For Code Compliance  
City of Ocala Growth Management

**KFC**  
3615 W SILVER SPRINGS BLVD.  
OCALA, FL

**MECHANICAL  
DIFFUSER AND  
DUCT PLAN**

**M2.0**

**DUCT AND DIFFUSER PLAN** 1/4"=1'-0" **A**

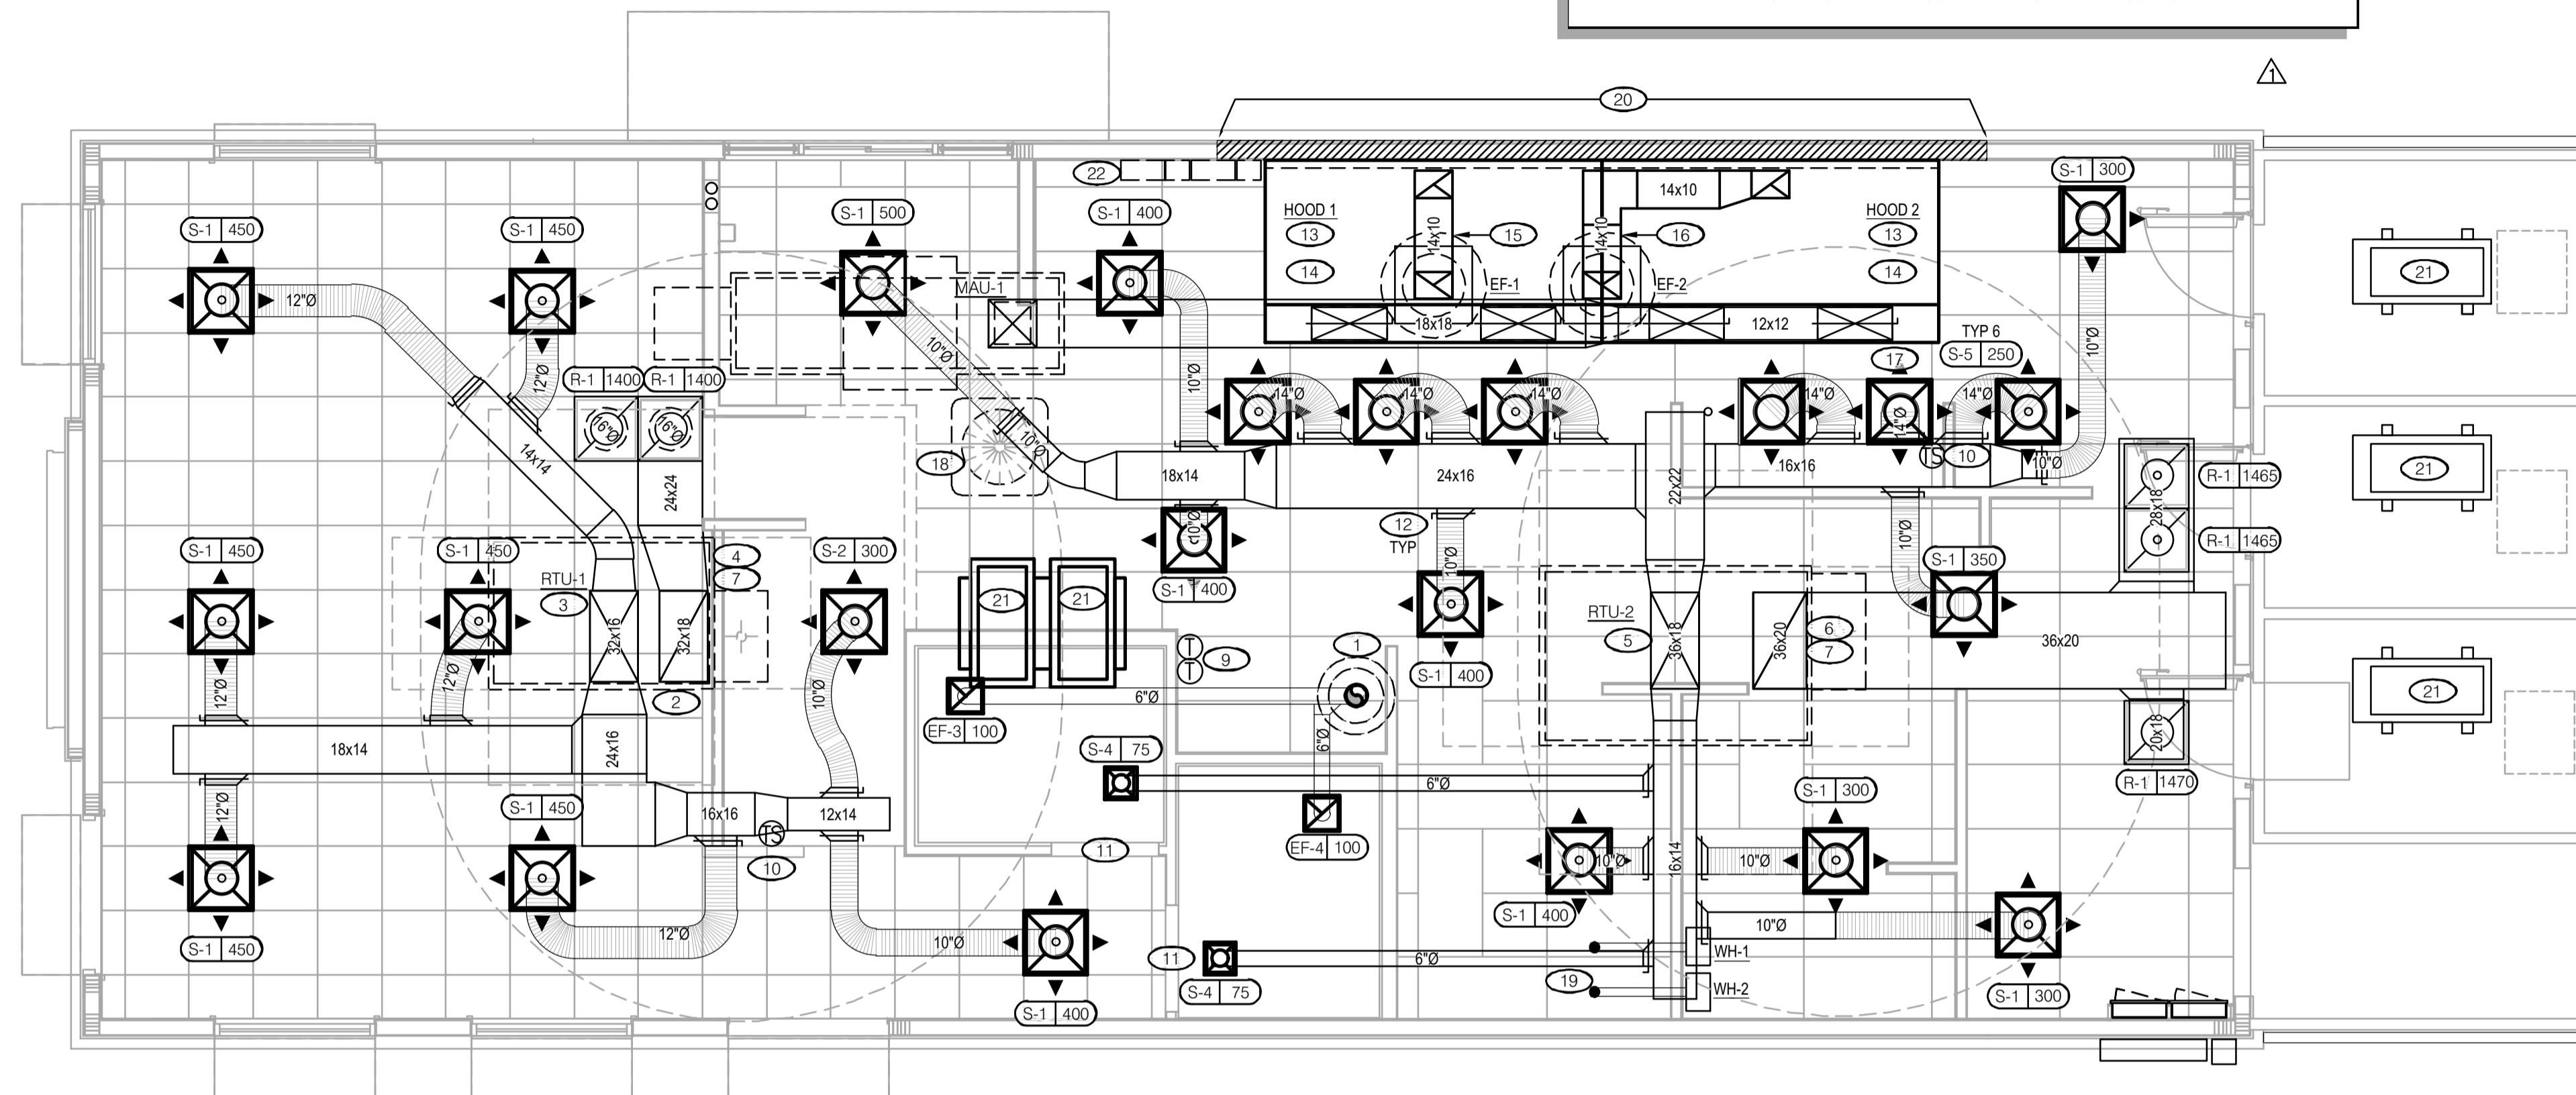
NOTE:  
THE HOOD FIRE SUPPRESSION CONTRACTOR SHALL SUBMIT PLANS FOR EVALUATION AND APPROVAL PRIOR TO COMMENCEMENT OF NEW WORK.

NOTE:  
PROVIDE SECONDARY CONDENSATE PROTECTION IN COMPLIANCE WITH FBC - MECH 307.2.3 AND RELATED SUBSECTIONS. PROVIDE SAFETY SHUT-OFF SWITCHES IN CONDENSATE DRAINS.
